Project No. P279

Revised Workplan
Soil and Groundwater Investigation
2440 East Eleventh Street
Oakland CA
RO No. 29

This letter provides revisions to our previous workplan, dated 28 June 2002.

Figure 4

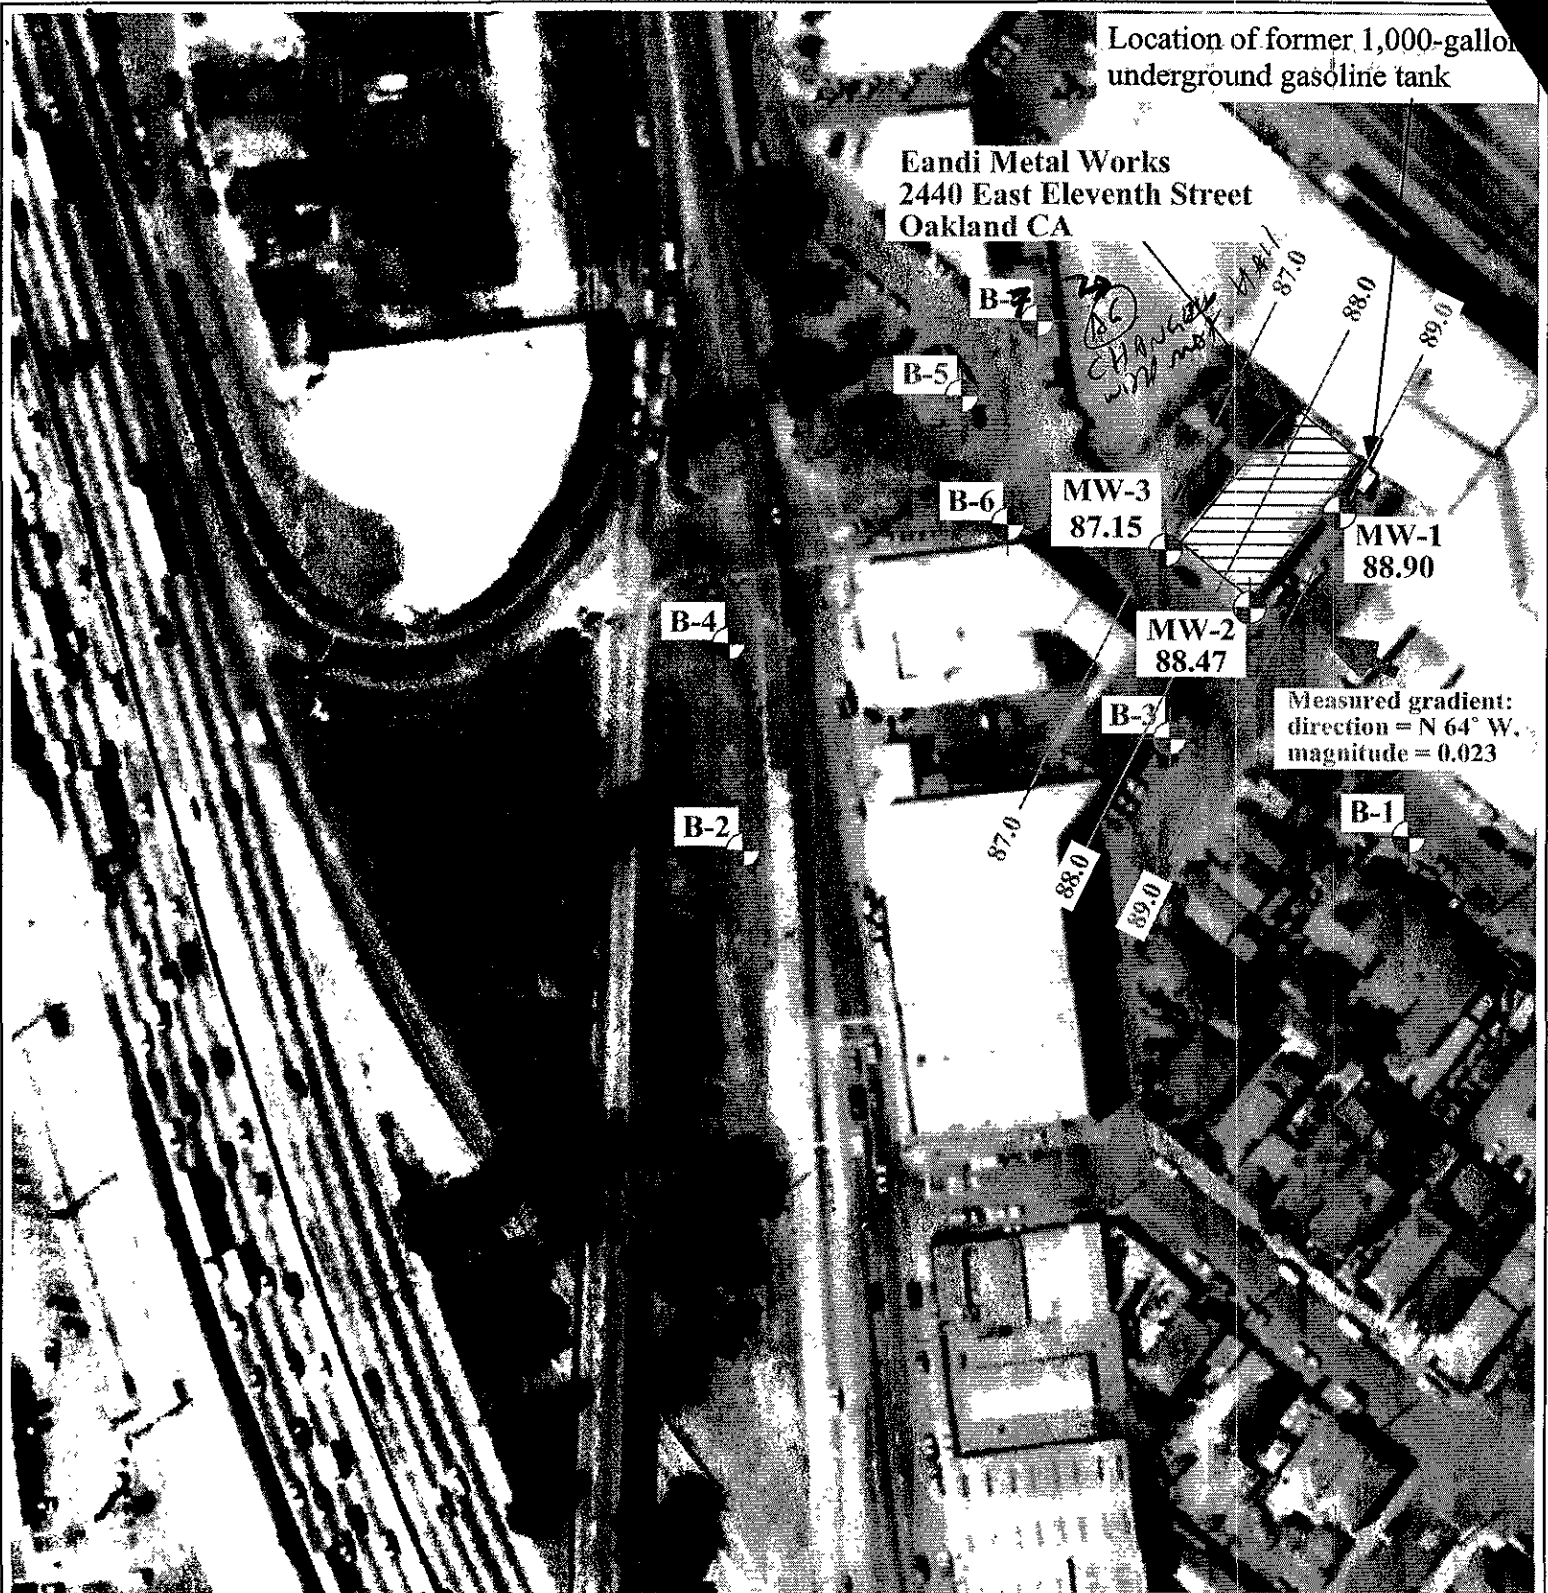
On 11 February 2002, Amir Gholami of the Alameda County Environmental Health Department called me to discuss our 28 June 2002 workplan. Mr. Gholami requested that the workplan be revised to provide selected Geoprobe borings that are closer to the former tank. We have revised the proposed locations of the Geoprobe borings in accordance with Mr. Gholami's direction. The new locations are shown on the attached Figure 4.

Figure 4
Groundwater Levels and Gradient (5 February 2002)
2440 East Eleventh Street
Oakland CA

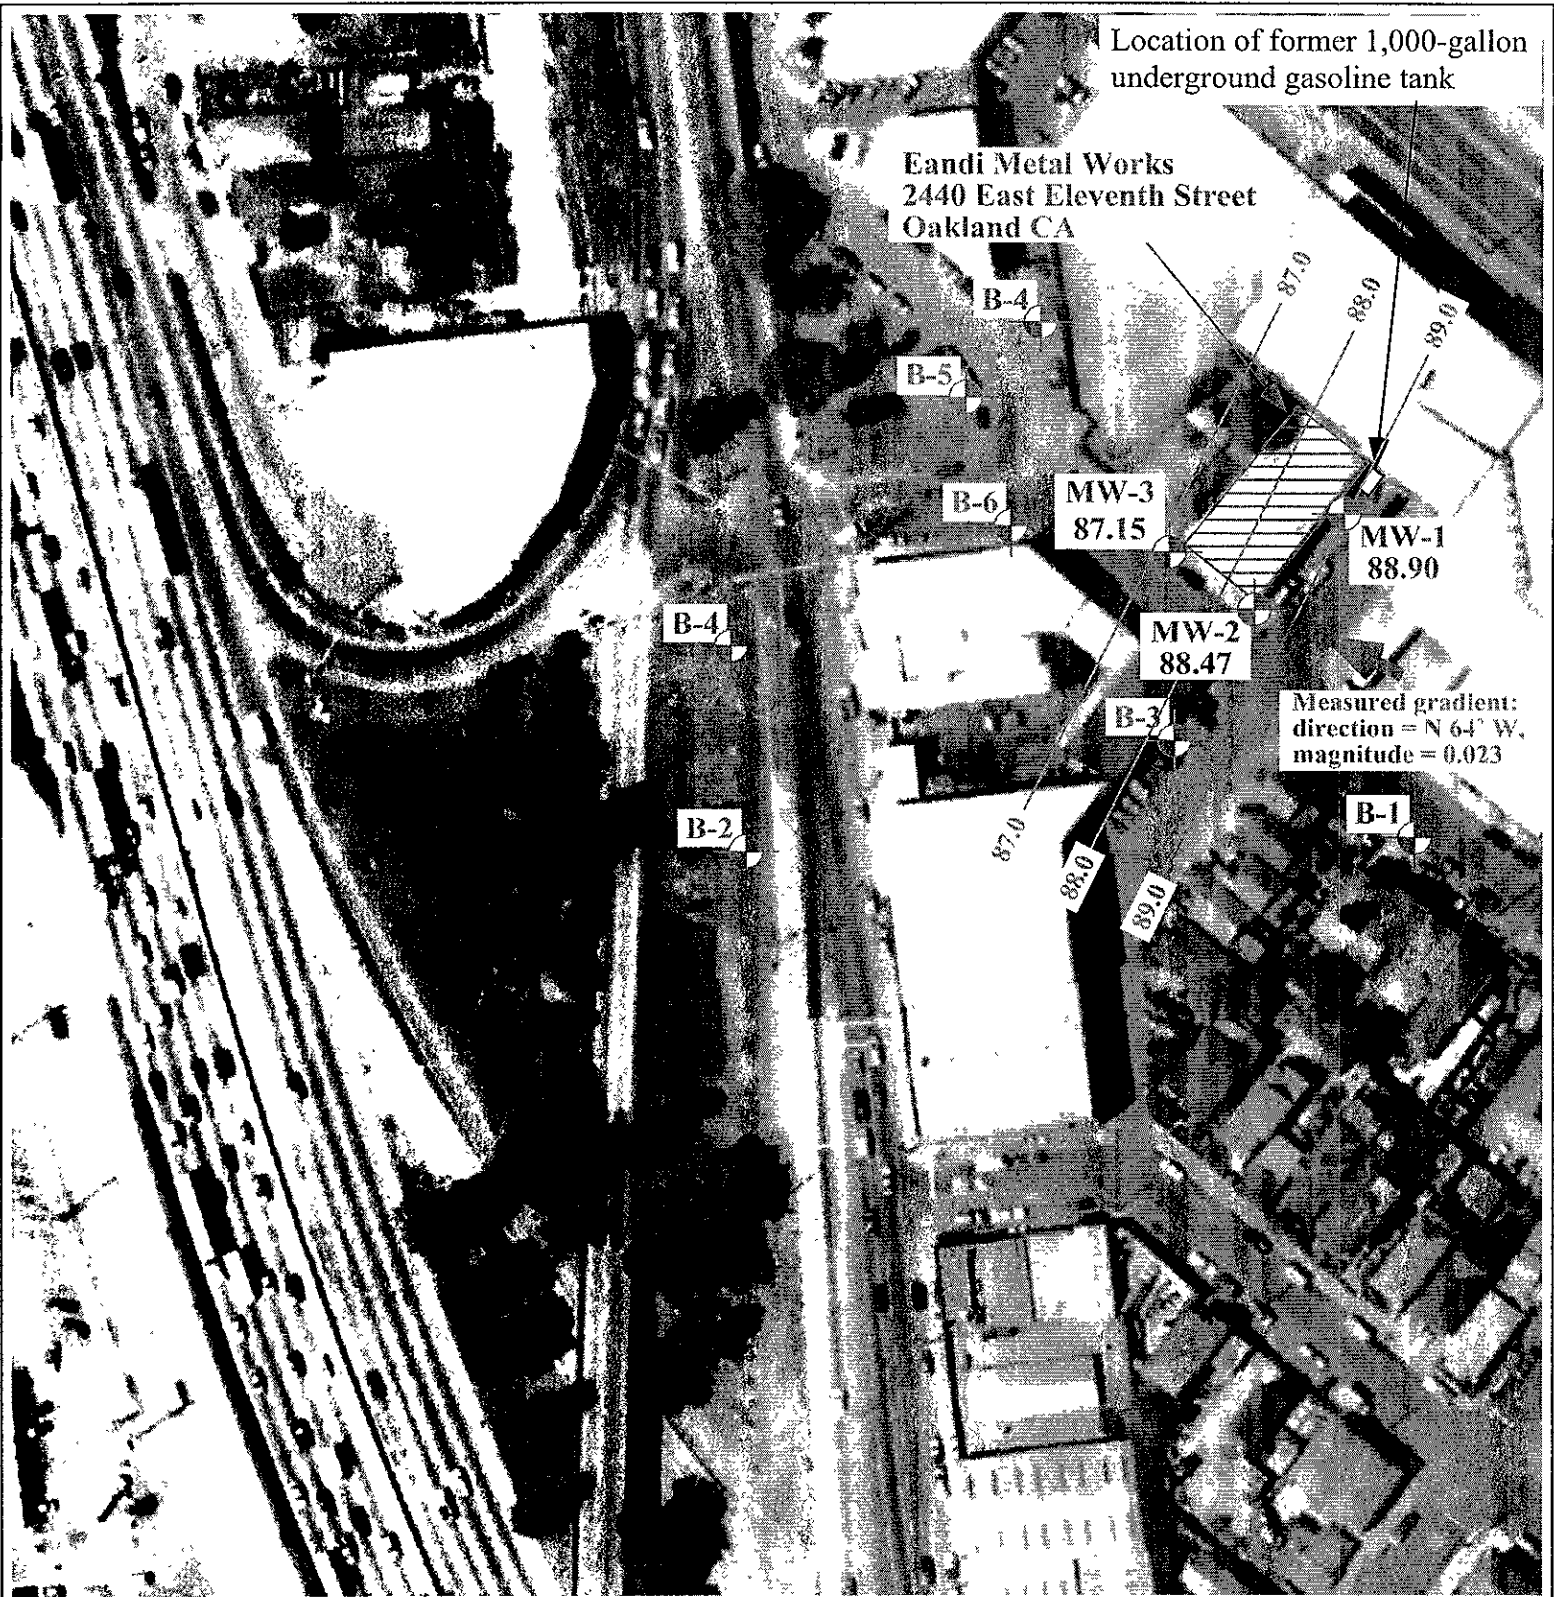
On 11 February 2002, Amir Gholami of the Alameda County Environmental Health Department called me to discuss our 28 June 2002 workplan. Mr. Gholami requested that the workplan be revised to provide selected Geoprobe borings that are closer to the former tank. We have revised the proposed locations of the Geoprobe borings in accordance with Mr. Gholami's direction. The new locations are shown on the attached Figure 4.
